10.4 Other Features of Steam and Power Conversion

The information in this section of the reference ABWR DCD, including all subsections, tables, and figures is incorporated by reference with the following departures and supplements.

Figure 10.4-6 Feedwater System

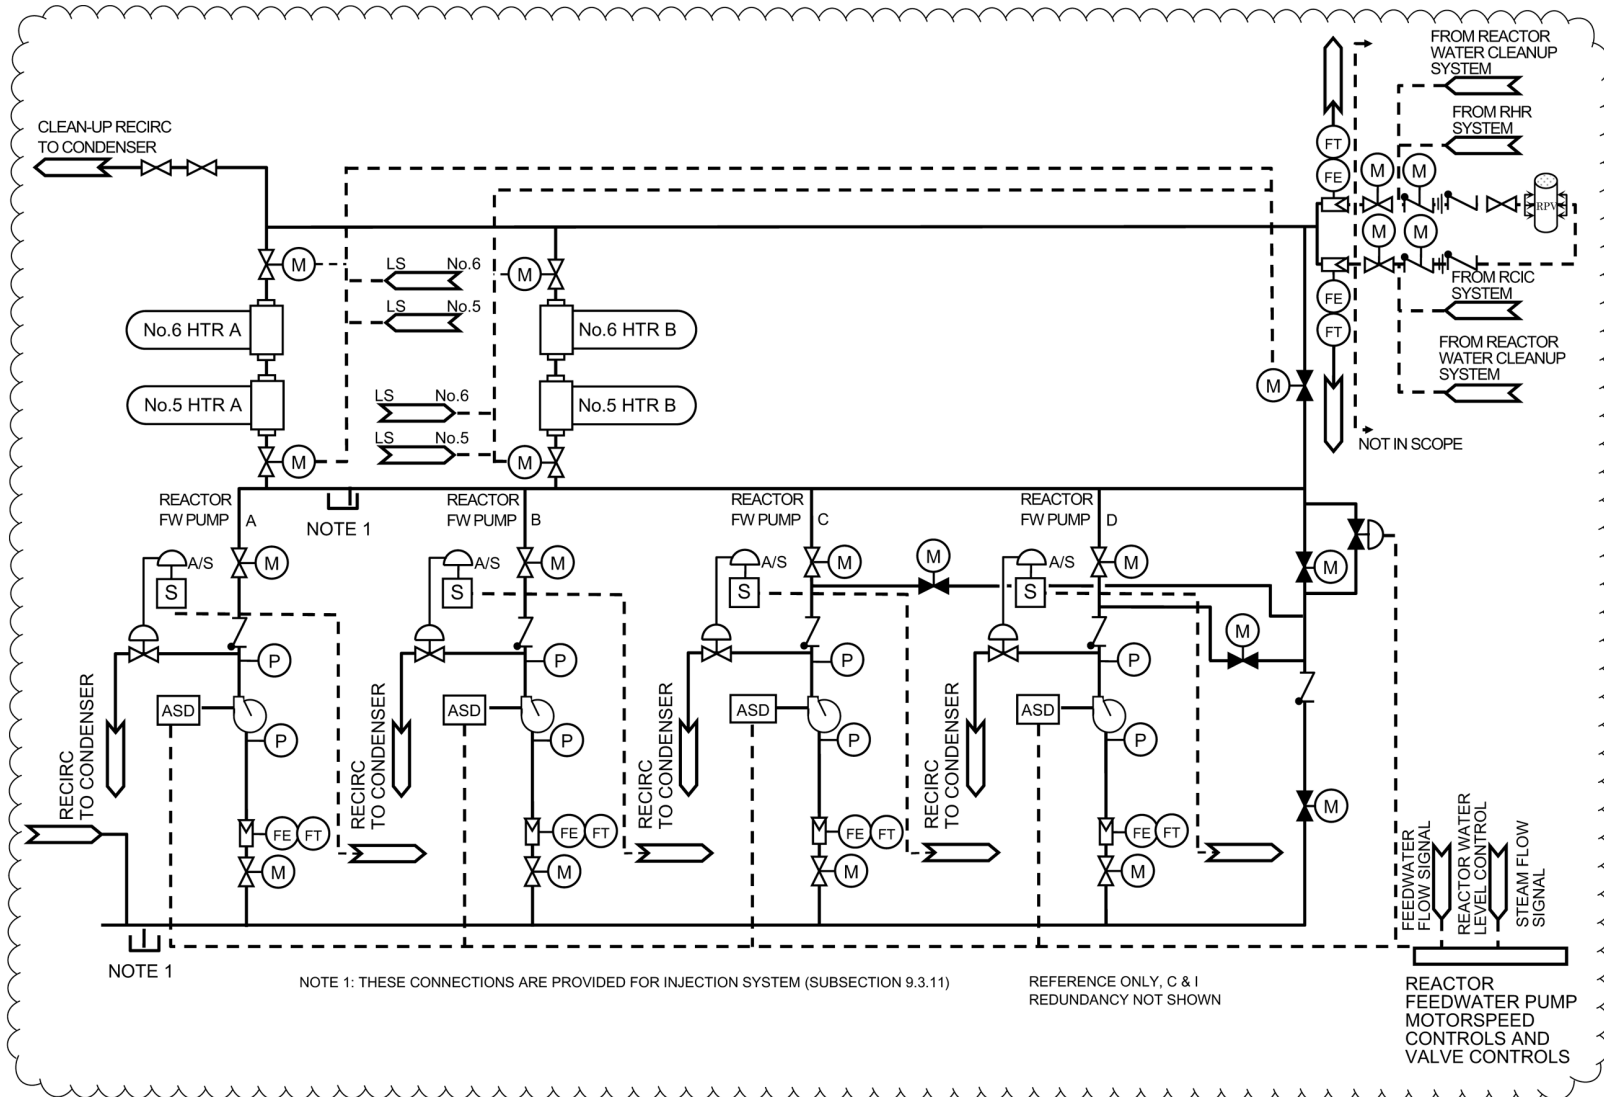
STD DEP 10.4-5 (Tables 10.4-4, 10.4-5 and 10.4-6, Figures 10.4-5, 10.4-6, 10.4-7, and 10.4-8)

The Condensate and Feedwater System (Figures 10.4-5 and 10.4-6) consists of the piping, valves, pumps, heat exchangers, controls and instrumentation, and the associated equipment and subsystems which supply the reactor with heated feedwater in a closed steam cycle utilizing regenerative feedwater heating. The system described in this subsection extends from the main condenser outlet to (but not including) the seismic interface restraint outside of containment. The remainder of the system, extending from the restraint to the reactor, is described in Chapter 5. Turbine cycle steam is utilized for a total of six stages of closed feedwater heating. The drains from each stage of the low-pressure feedwater heaters are cascaded through successively lower pressure feedwater heaters except the lowest and second lowest pressure feedwater heaters which drain to the low pressure heater drain tanks for each string. The drains from each low pressure heater drain tank flow into the external drain coolers of each lowest pressure feedwater heater and finally to the main condenser. The high pressure heater drains are pumped backward to the reactor feedwater pumps suction. The cycle extraction steam, drains and vents systems are illustrated in Figures 10.4-7 and 10.4-8.

Reactor Feedwater Pumps—~~Three~~ Four identical and independent ~~33–65%~~ 33% capacity reactor feedwater pumps (RFP) are provided. ~~The~~ Three pumps normally manually operate in parallel and discharge to the high-pressure feedwater heaters. The pumps take suction downstream of the last stage low-pressure feedwater heaters and discharge through the high-pressure feedwater heaters. Each pump is driven by an adjustable speed drive.

Figure 10.4-9 Bypass Valve Control, Electro-Hydraulic Control Unit

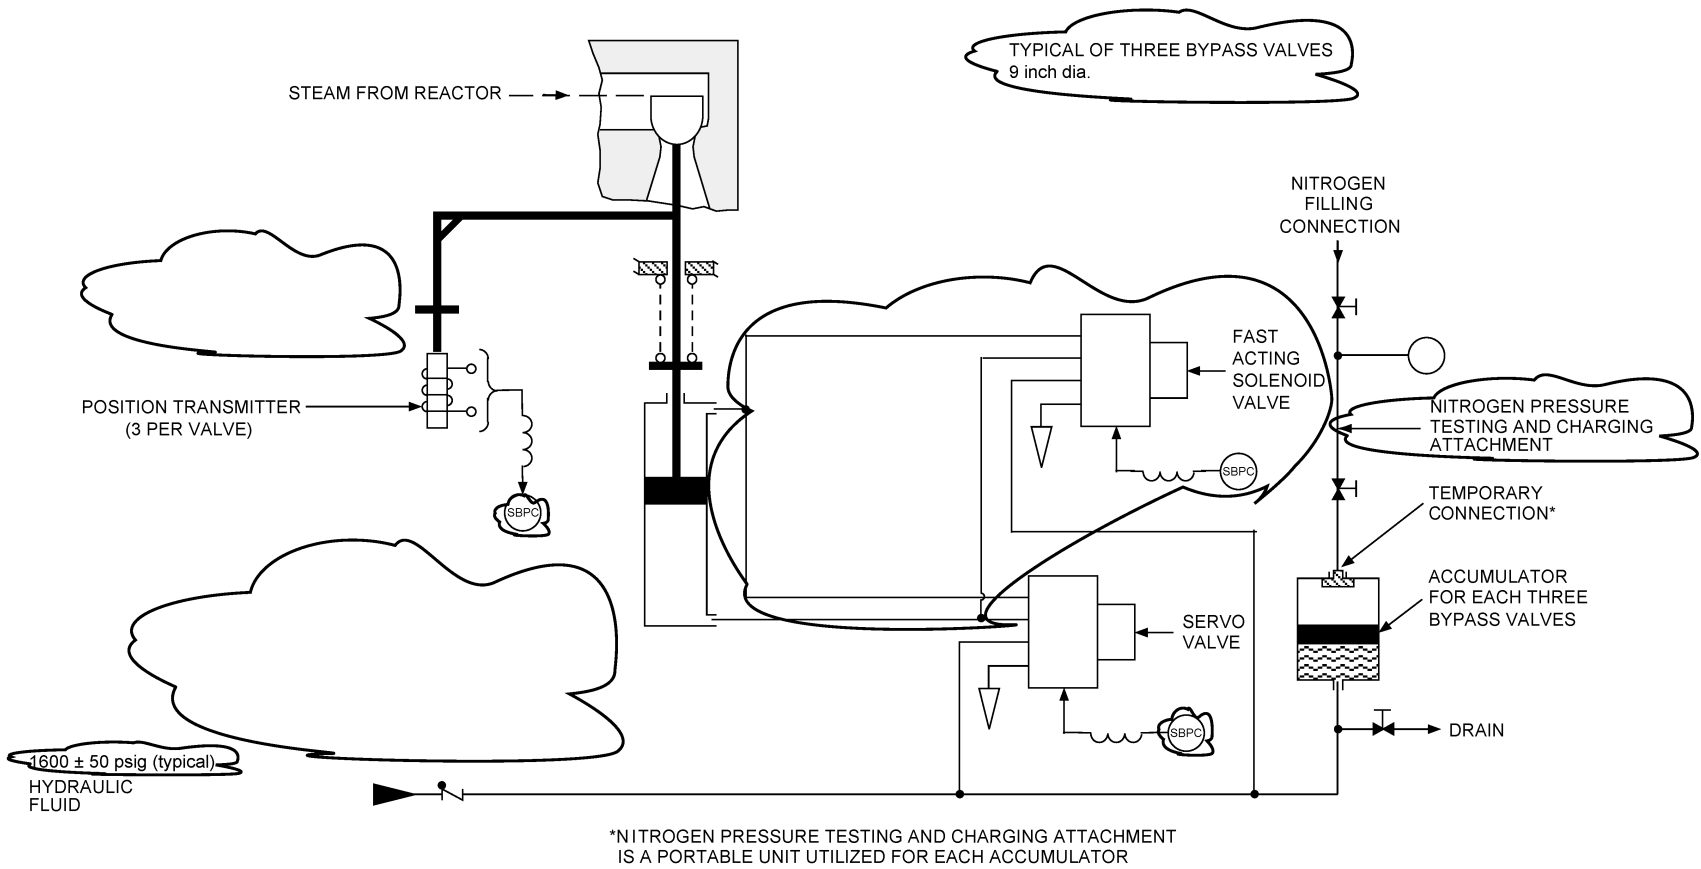
STD DEP 10.4-7 (Figure 10.4-9)
